Bei den Auswerteeinheiten
BIS C-600-022-...-00-KL1
ab HW-Stand V2.0 ist folgendes
zu beachten:

Please note with the Processor units BIS C-600-022-...-00-KL1 since HW version V2.0:

Verdrahtungshinweis

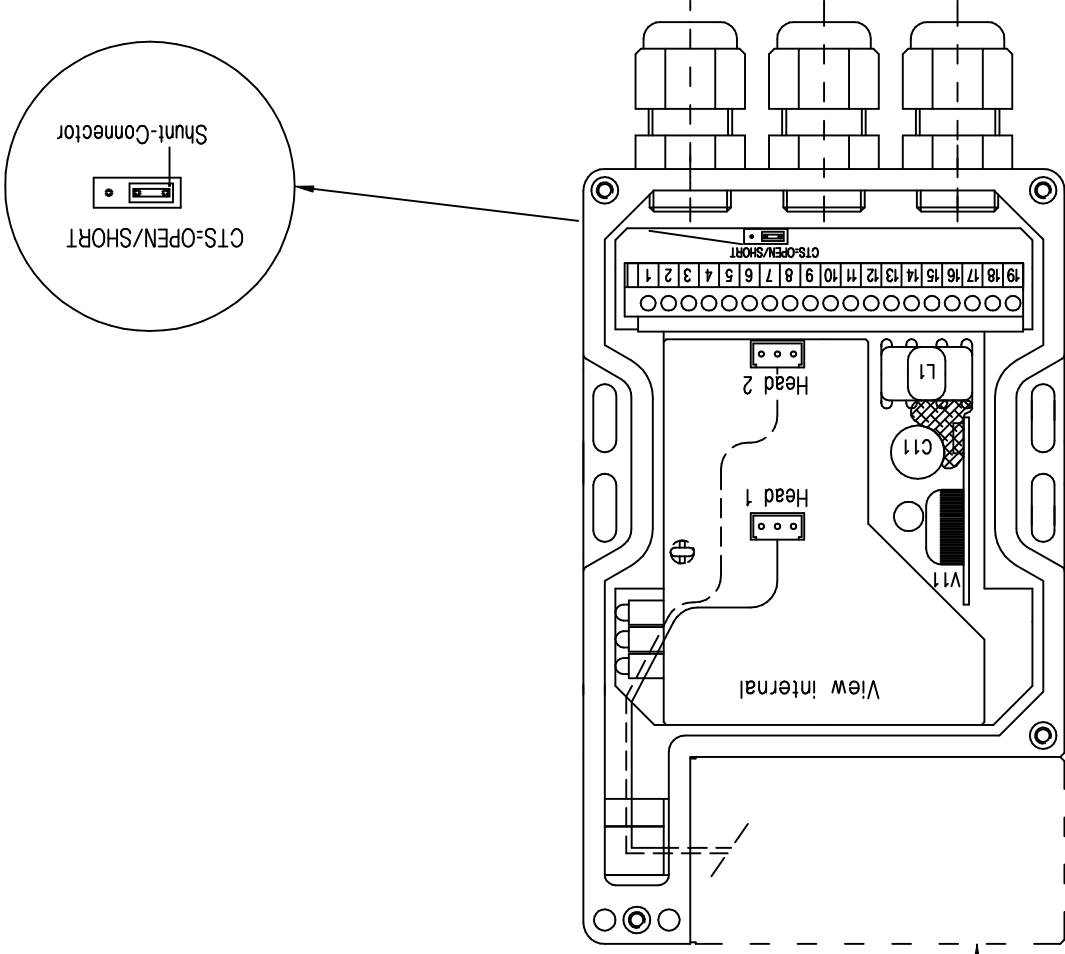
1. Ein externer Schreib-/Lesekopf kann nicht mehr an die Klemmleiste angeschlossen werden. S.58 des Handbuches entfällt ersatzlos.
2. Anschluss an die Klemmleiste siehe beiliegendes Datenblatt.

Wird das Steuersignal CTS nicht verwendet, muß der Shunt-Stecker in Position "SHORT" gesteckt werden.

Notes
If not use CTS, Shunt-Connector must be in position "SHORT".

1. You can't connect an external read-/write head to the terminal block.
Page 58 of the manual is no longer valid.

2. Connection to the terminal block see attached datasheet.
